N R Knitting Mills Limited. (Extension)

16 February 2025

1. Building Information

Observation-2: Mismatch between drawing & onsite condition (Childcare & Medical building).

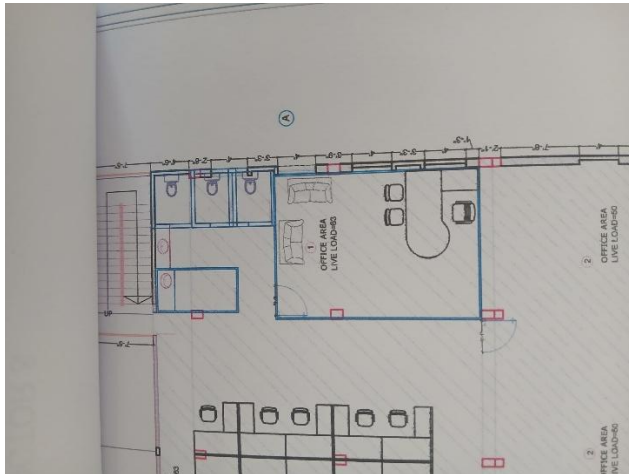
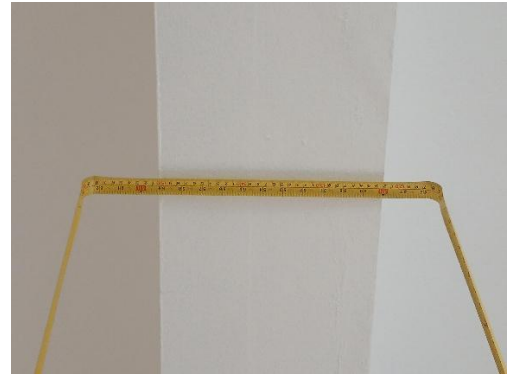
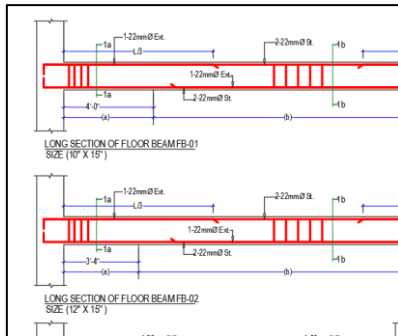
Description: During inspection, FB1 and FB2 were measured 10"X18" and 10"X20" which were shown 10"X15" and 12"X15" respectively in available structural drawing. In addition, 12" (300 mm) buildup was observed in the toilet block area which was not shown in available architectural drawing. The building engineer is required to update the drawing based on the as-constructed structure.

2.		Carry out remedial work if required.	within 6 months
3.		Continuing to implement loan plan	within 6 months
4.	Mismatch between drawing & onsite condition (Childcare & Medical building).	The building engineer is required to update the drawings to the as-constructed status.	within 6 weeks

Observation 3: Dampness on roof slab and cracks on masonry walls (Childcare & Medical building).

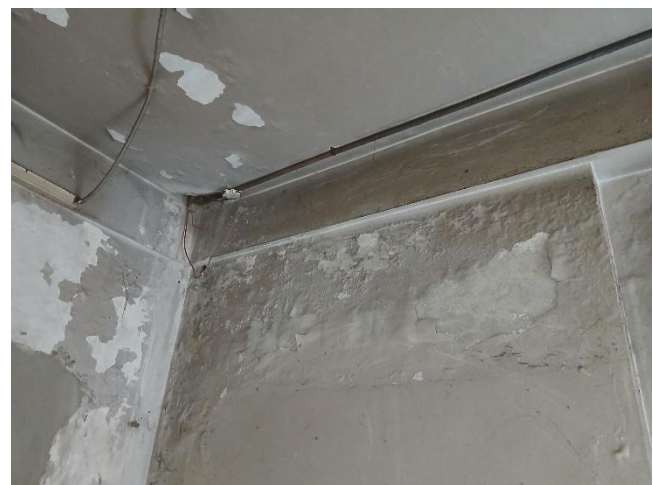
Description: Dampness on roof slabs and cracks on masonry walls were observed. The building engineer is required to investigate the reason for dampness & cracks; and repair following suitable method.

5.	Dampness on roof slab and cracks on masonry walls (Childcare & Medical building).	The building engineer is required to investigate the reason for dampness & cracks; and repair following suitable method.	within 6 weeks

Observation 5: Corrosion on steel members of the steel stair (Childcare & Medical building).

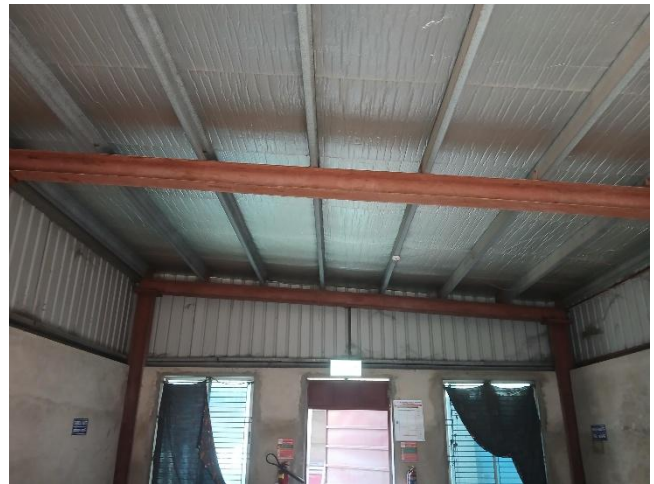
Description: Corrosion was observed on steel members of steel stairs. The building engineer is required to provide rust-proof paint on steel members.

8.		Carry out remedial work if required.	within 6 months
9.	Corrosion on steel members of the steel stair (Childcare & Medical building).	The building engineer is required to provide rust-proof paint on steel members.	within 6 weeks
